**FINAL DRAINAGE REPORT  
FOR  
LATIGO TRAILS FILING NO. 10  
AND  
ADDENDUM TO MASTER DEVELOPMENT/  
PRELIMINARY DRAINAGE PLAN  
FOR LATIGO TRAILS,  
EL PASO COUNTY, COLORADO**

September 2021

**JR ENGINEERING**  
5475 Tech Center Drive  
Colorado Springs, CO 80919  
(719) 593-2593

Job No. 25175.02

# Crossing - BUFFALO RIVER CROSSING, Design Discharge - Culvert - Culvert 1, Culvert Discharge - 137.5 cfs

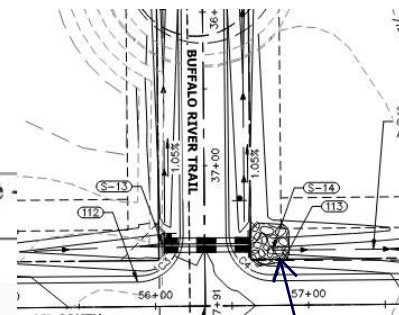
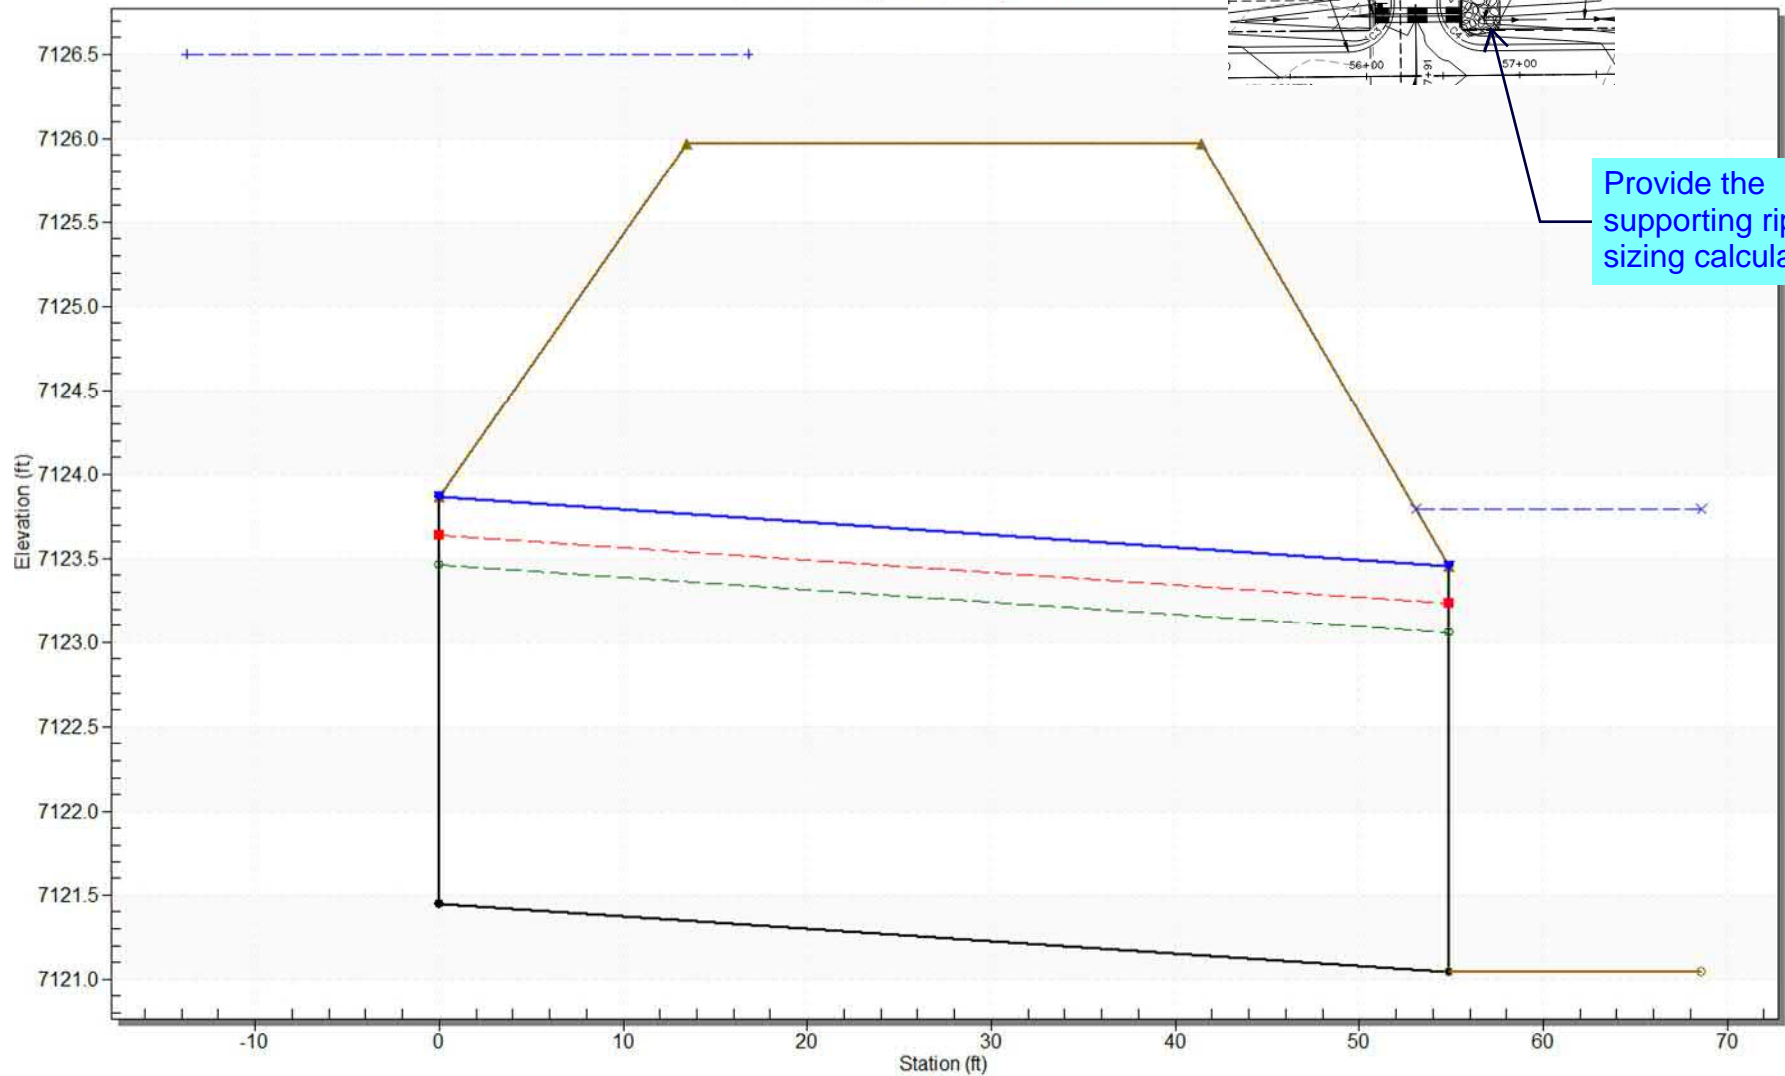
Provide the supporting riprap sizing calculation

Include the additional Hy-8 input/output data.

Hw/D appears to be greater than 1.5. Revise to meet criteria which is allowable Hw/D shall be less than 1.5.

# DETENTION BASIN STAGE-STORAGE TABLE BUILDER

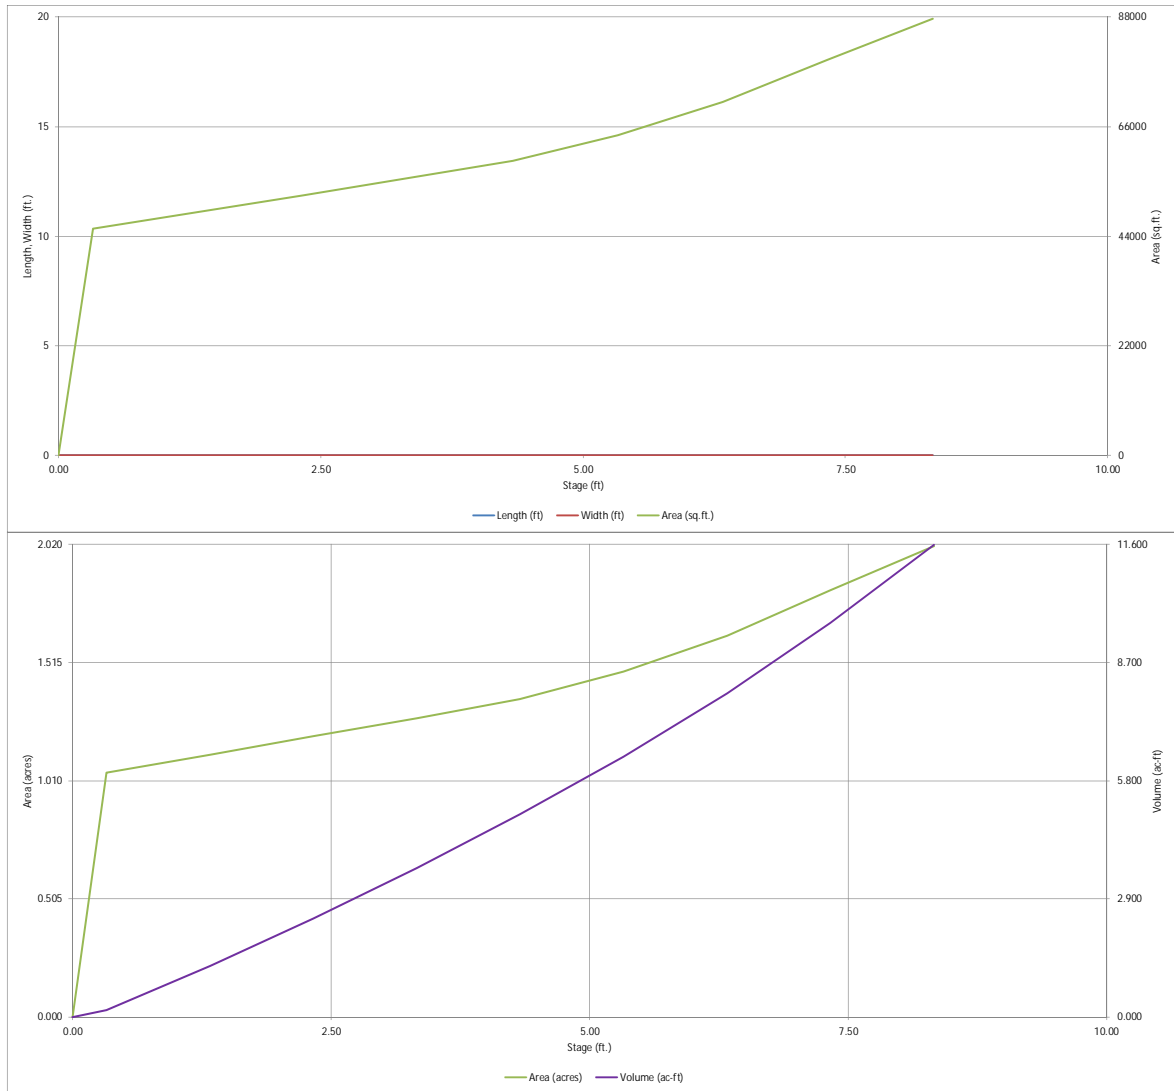
This and other pond calcs will be reviewed in more details once pond outlet details/sections are provided in CD's.

LATIGO TRAILS FILING NO. 10 ULTIMATE CONDITIONS

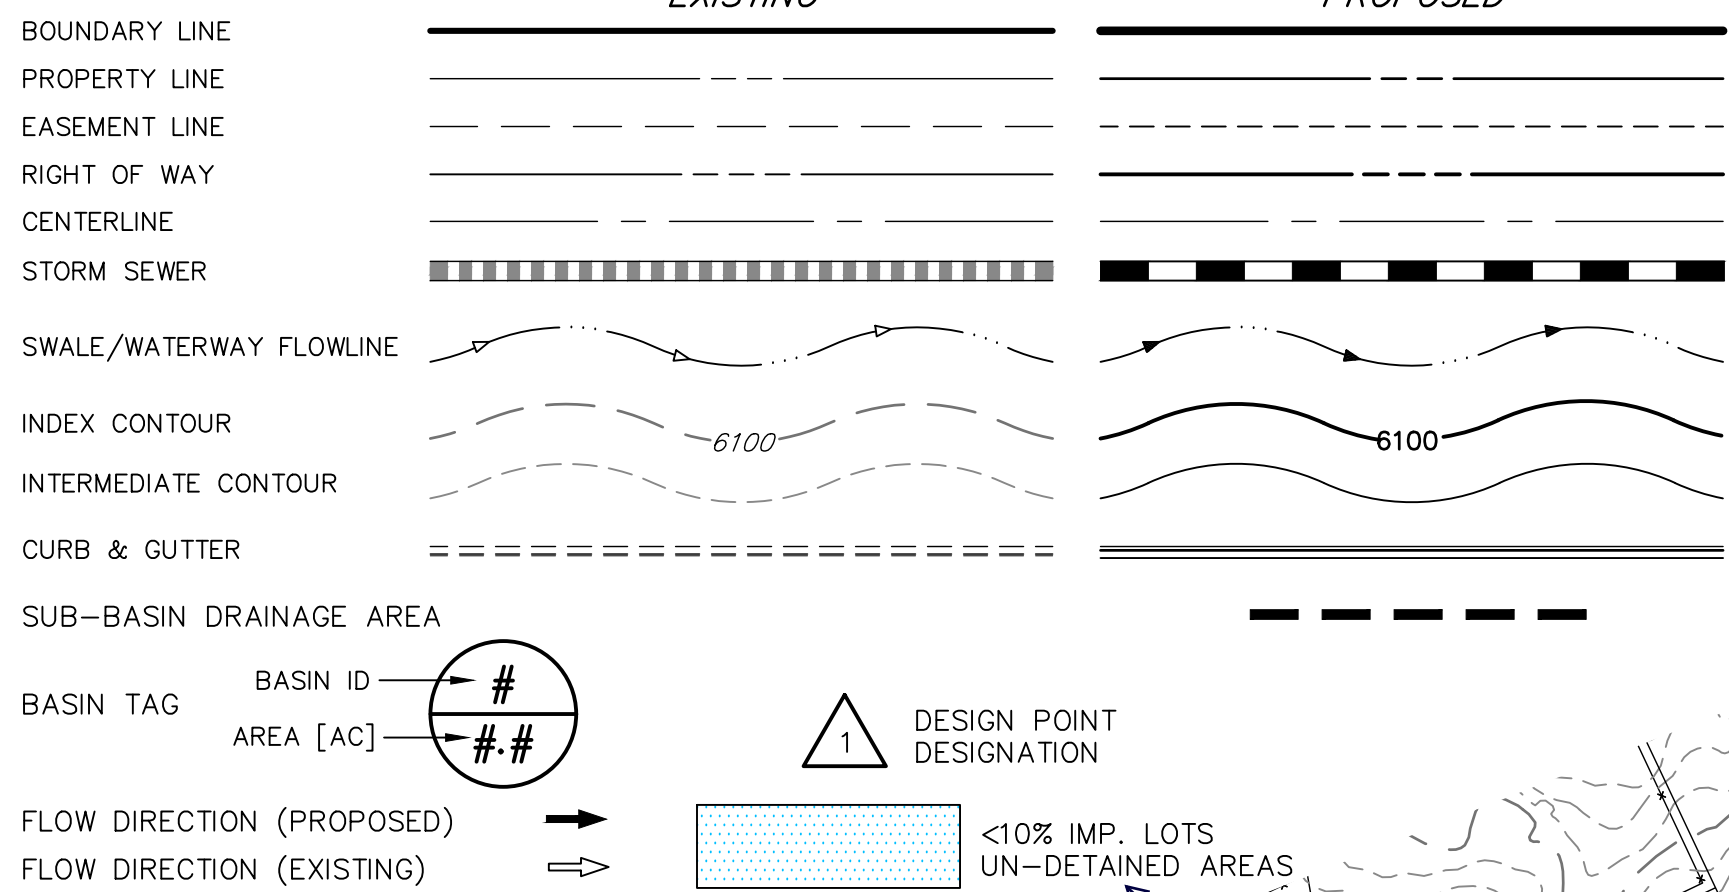
This is a duplicate of the next sheet. This should be the "Existing Drainage Map"

PROPOSED DRAINAGE MAP  
LATIGO TRAILS FILING NO. 10  
JOB NO. 25175.02  
09/16/2021  
SHEET 1 OF 1

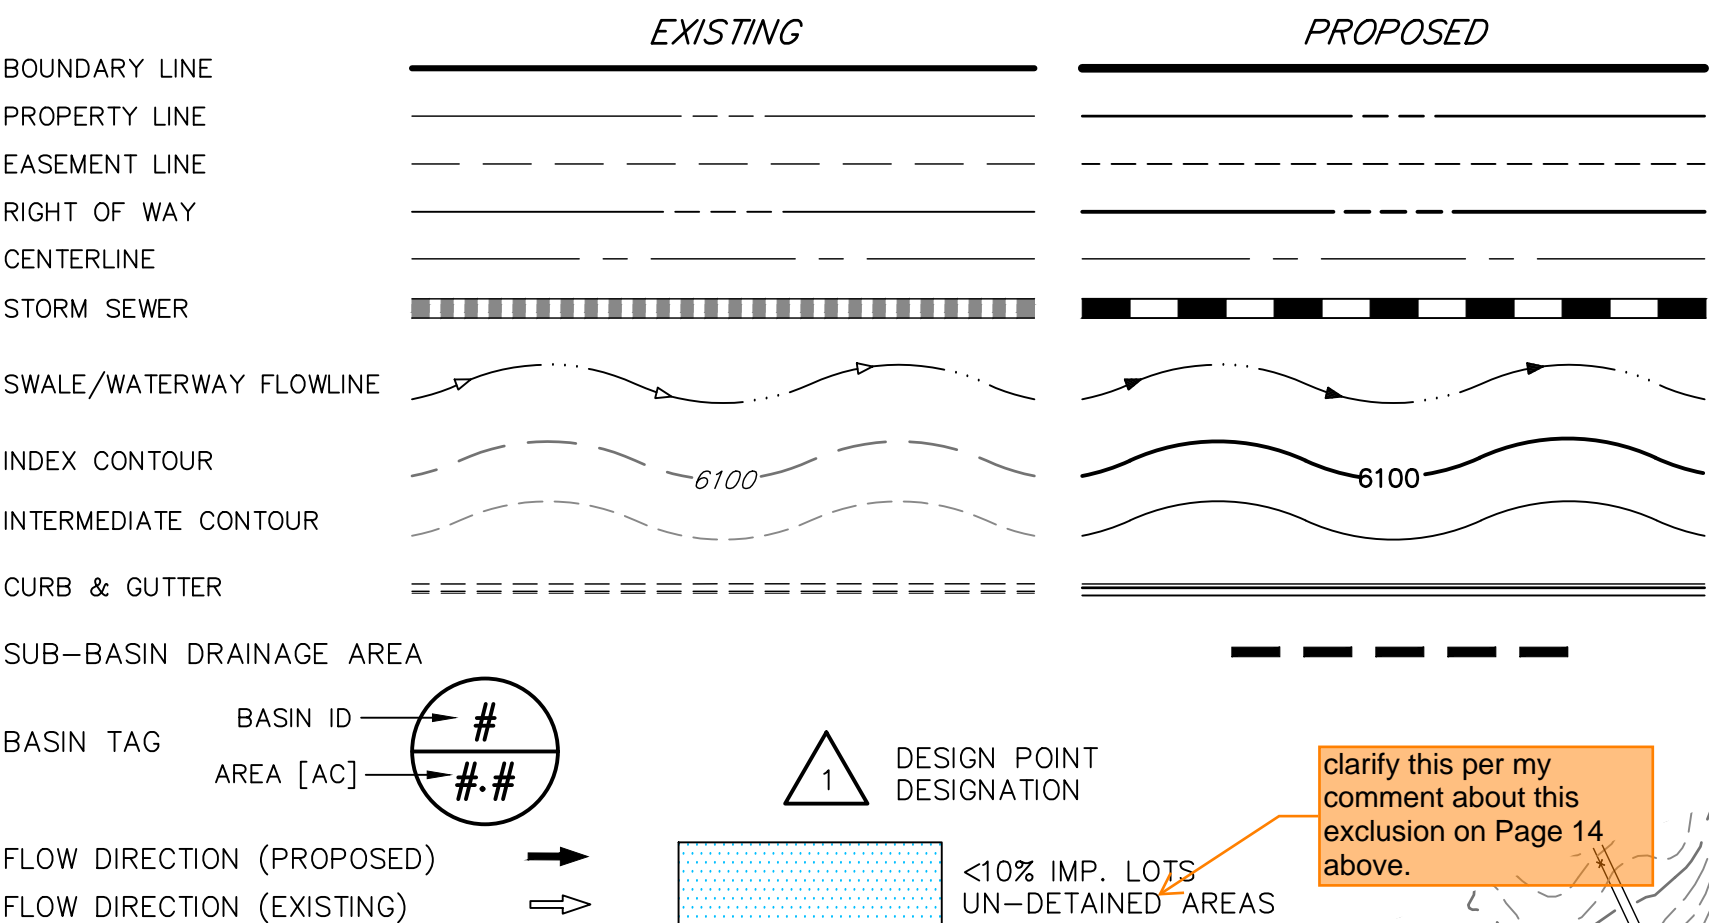
show a few more drainage flow arrows  
- on this map or a new one, include color shading that shows areas tributary to each type of PBMP (each pond, runoff reduction, etc.) and those areas that are not captured by a PBMP, with the applicable exclusion(s) labeled --- for this filing.  
A summary table on the map would also be acceptable (example provided):

Calculate the required driveway culvert size for all the lots in Filing 10. Provide a summary table listing each lot in the subdivision and the anticipated culvert size. See example to the right. Standard culvert size is 18"

Add a section in the narrative regarding the summary table for the required driveway culvert sizing.

(FYI: See plat redline comment which includes a plat note regarding the driveway culvert sizes)

label the radius of curvature (highlighted sections). Verify the bends meet ECM Section 3.3.3.2. (see snippet below)

Update the drainage report to include additional analysis of the bends to verify no additional riprap erosion protection is required. See DCM section 10.5.6 and Hydraulic Engineering Circular (HEC) No. 15 - Design of Roadside Channels with Flexible Linings, specifically section 3.4. Per figure 3.3 the highest shear stress is at the outside bend in the vicinity of the PT.
